**RE: The Lofts at Winrock
7500 Indian School Road
Grading and Drainage Plan
Engineer's Stamp Date: 1/26/22
Hydrology File: J19D089**

Based upon the information provided in your submittal received 4/6/2022, the Grading & Drainage Plan **is not** approved for Grading Permit. The following comments need to be addressed for approval of the above referenced project:

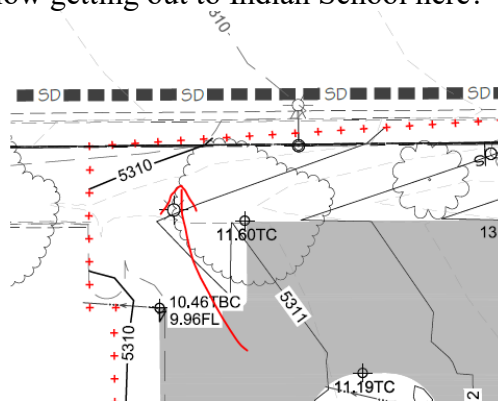
- i.
8. Is the grey shaded area all proposed pavement? If so, will off-site stuff be constructed as part of this building permit?
 9. Note: all work within public right-of-way will need to be constructed with a DRC work order.
 10. Please clearly note what is proposed. It is not clear on the grading plan if sidewalk culverts shown will be constructed with this? If so, please contact me and we will need some notes added to the plans that I can provide.
 11. Please provide benchmark and datum.
 12. How is flow getting out to Indian School here?

GRADING PLAN

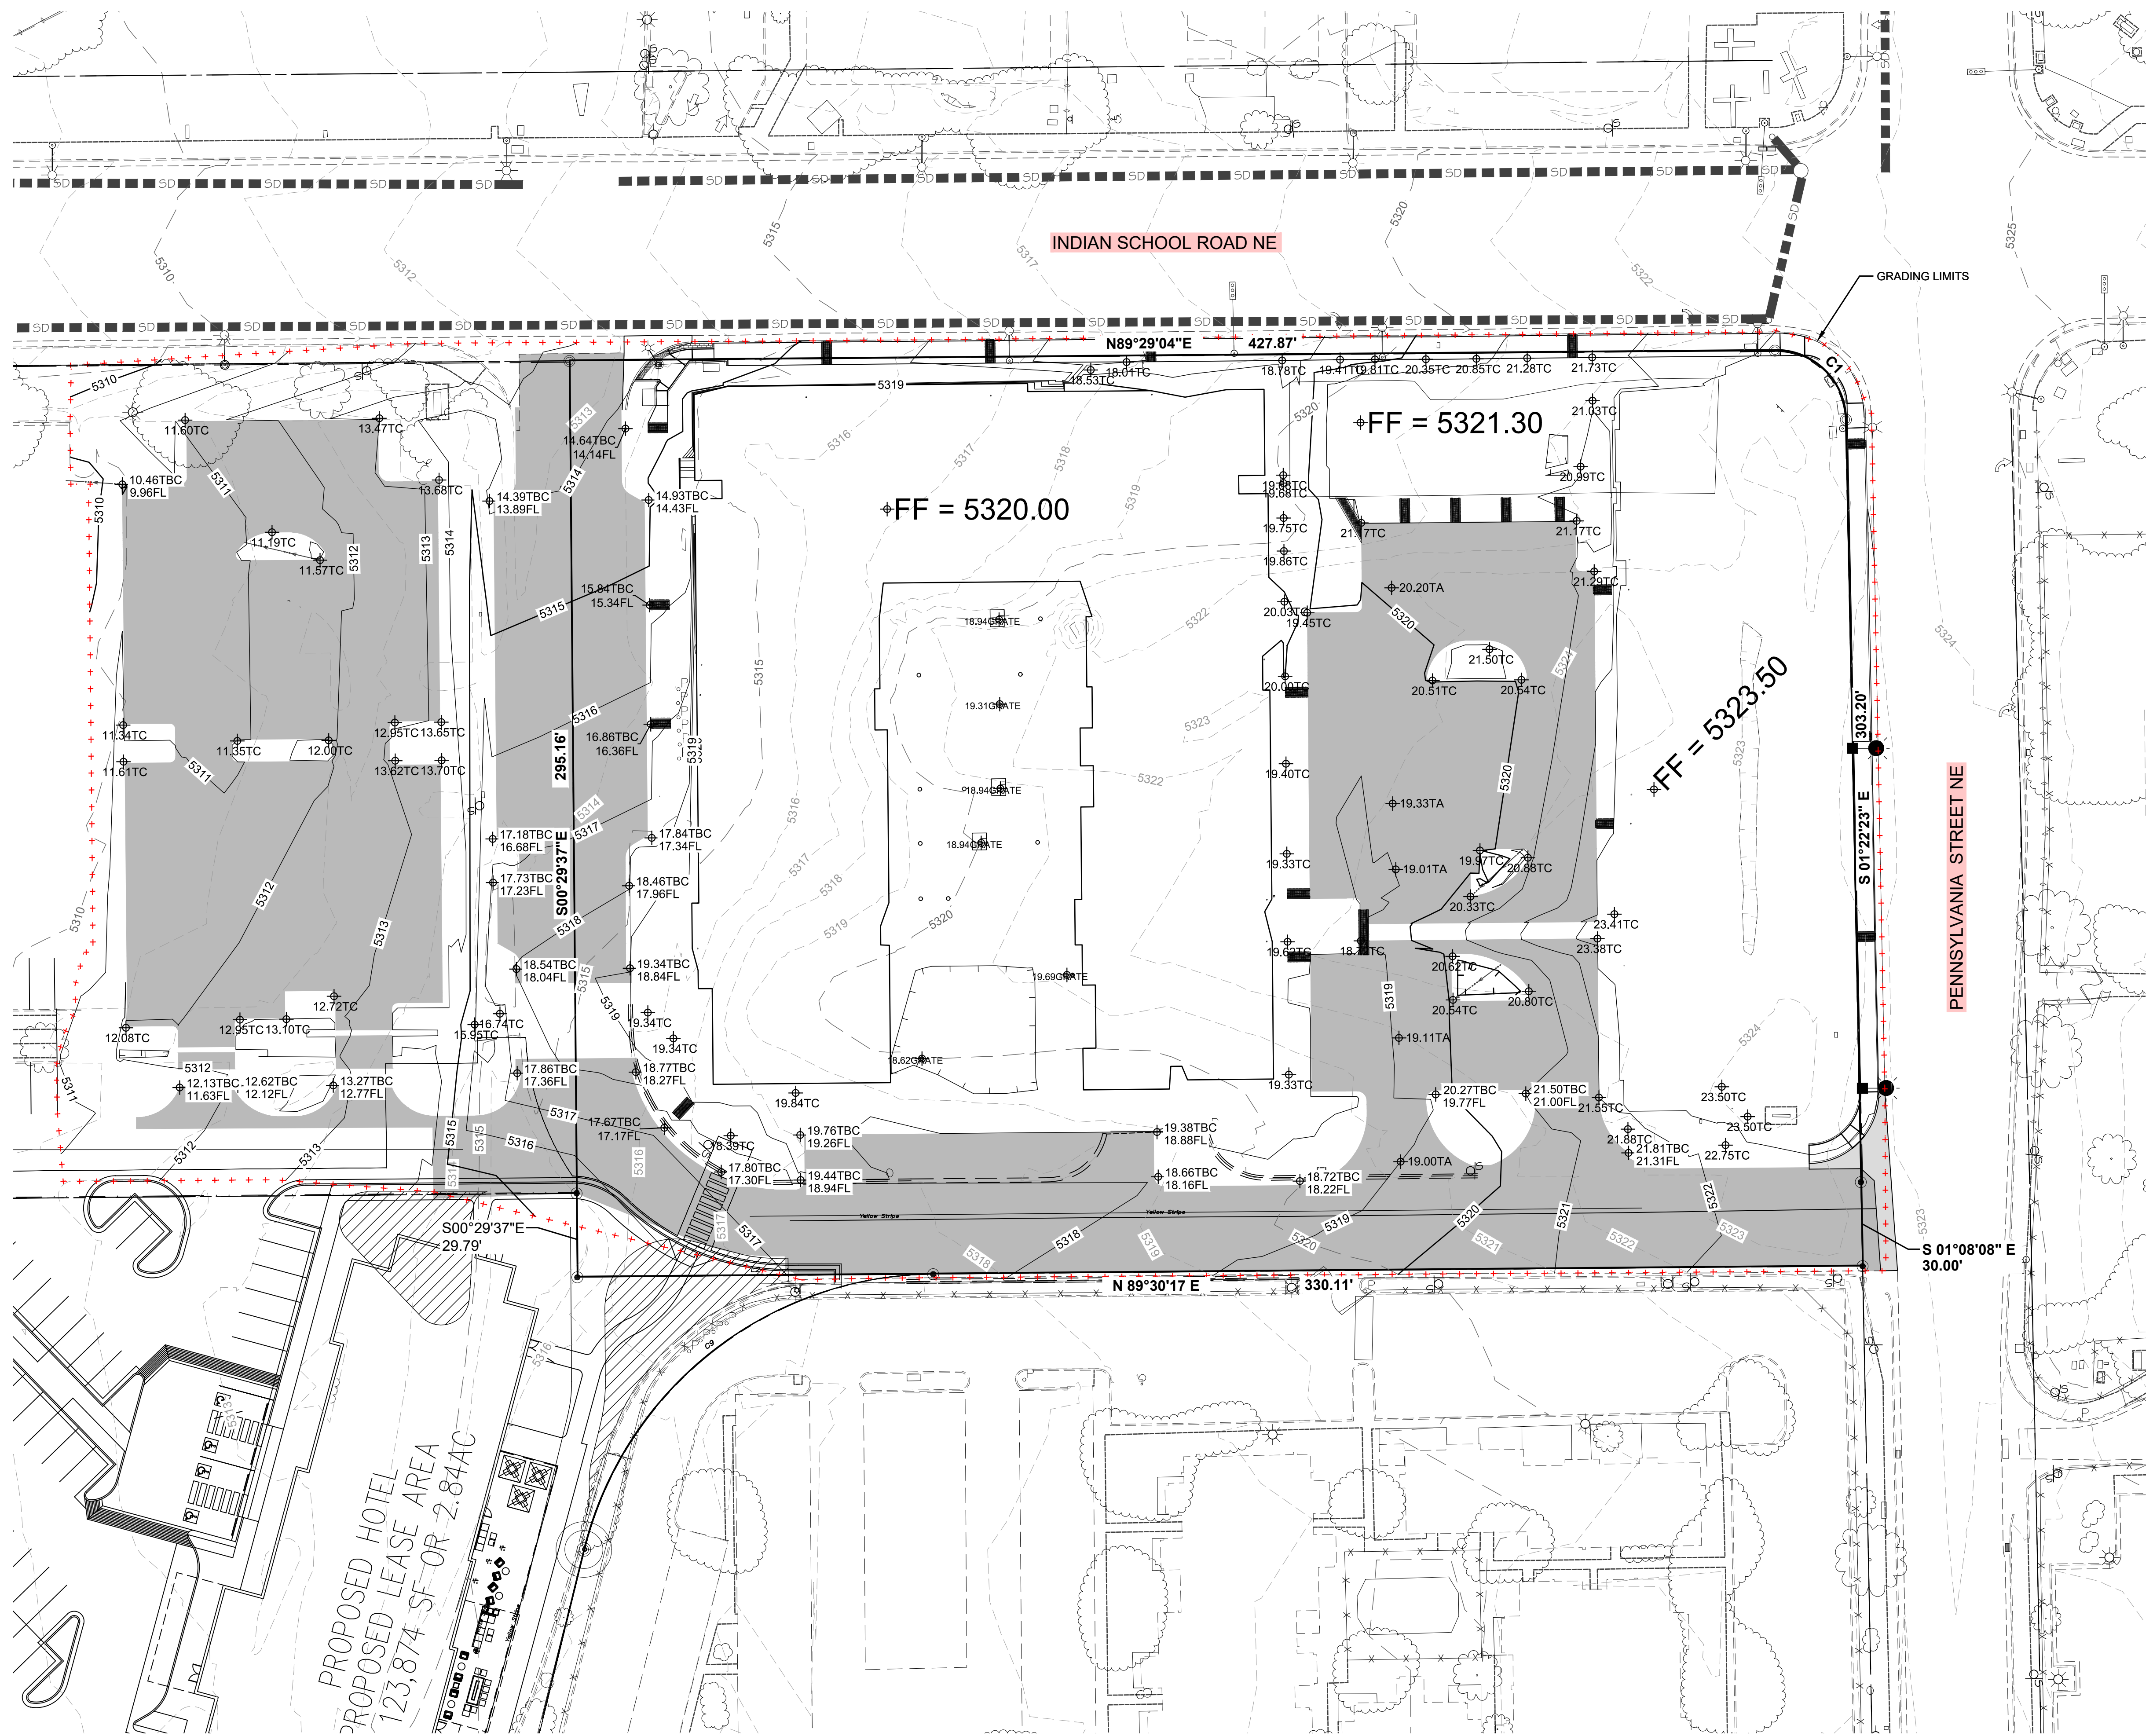
1. Please use 1:20 scale on the G & D.
2. The site does not qualify for redevelopment. Please calculate the required storm water quality volume for undeveloped using the corrected value of 0.42 and not 0.26.

3. The G & D needs to utilize the revised DPM Chapter 6 not the old DPM Chapter 22.
 - a. Please revise and resubmit with proper calculations.
4. Please show storm pipe on the grading plan with pipe materials.

- a. Also show where this drains to. Winrock place?
 - b. There should be an overall sheet showing how everything works together.
5. Please provide a legend explaining what your points mean. (i.e. 19.33TA I assume is top of asphalt? 20.51TC top of curb?. TBC? FL (flowline) – Please clarify so we do not have to guess.)

6. Please clearly define Storm Water Quality Ponds and proposed volumes (include sections for each showing the outlet elevation, water surface of retained volume, 100 yr elevation and bottom elevation.)

- a. Payment in lieu will not be approved for this site so please ensure to include ponding for the required volume once updated.
 - b. It is unclear how water is entering the depressed areas with the shown plan.

- i. Curb openings? Please show and make it clear.
7. Please review the conceptual G&D that was approved and include more details. It appears some detail was lost.
